# SEATTLE PACIFIC UNIVERSITY MAJOR INSTITUTION MASTER PLAN

# SEATTLE PACIFIC UNIVERSITY REVISIONS to the PRELIMINARY DRAFT MIMP

Potential reuse: W Etruria St looking northeast

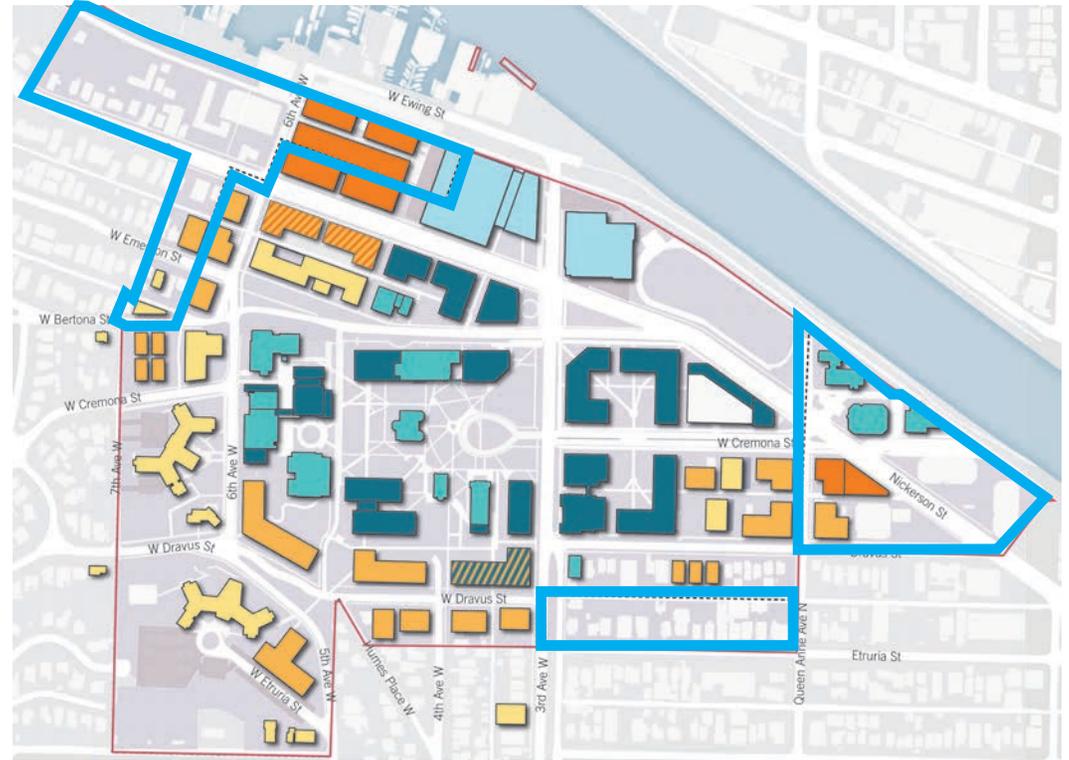
- Height limits and development standards for Etruria expansion area are incompatible with surrounding neighborhood.

- SPU would reuse existing buildings, not build new.
- Changed proposed height limit to 50 (10-foot increase from underlying and surrounding zones).
- Topography variation from north to south is greater than 10 feet.

Revised Building Use Diagram

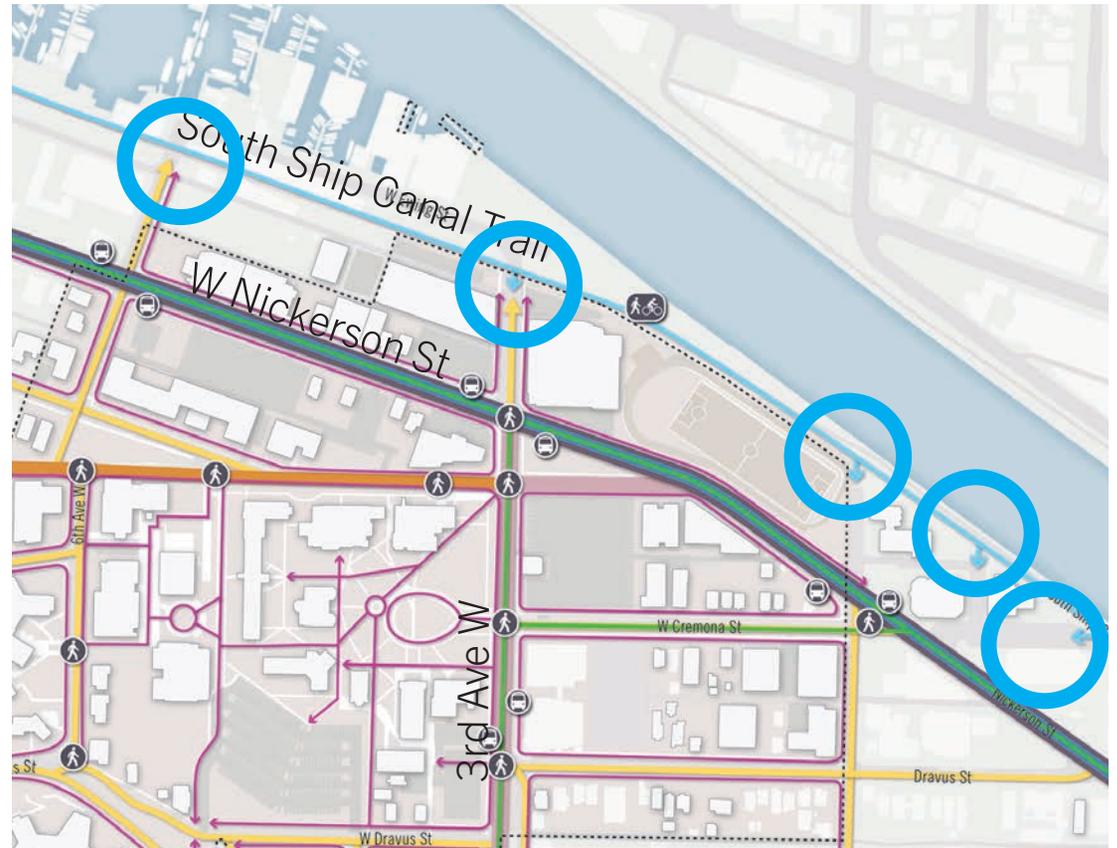
- Consider making connections to larger open spaces and South Ship Canal Trail network.

- South Ship Canal Trail connections already exist. SPU will continue to support connections to the trail and other open spaces.
- Added connectivity map and descriptive text.
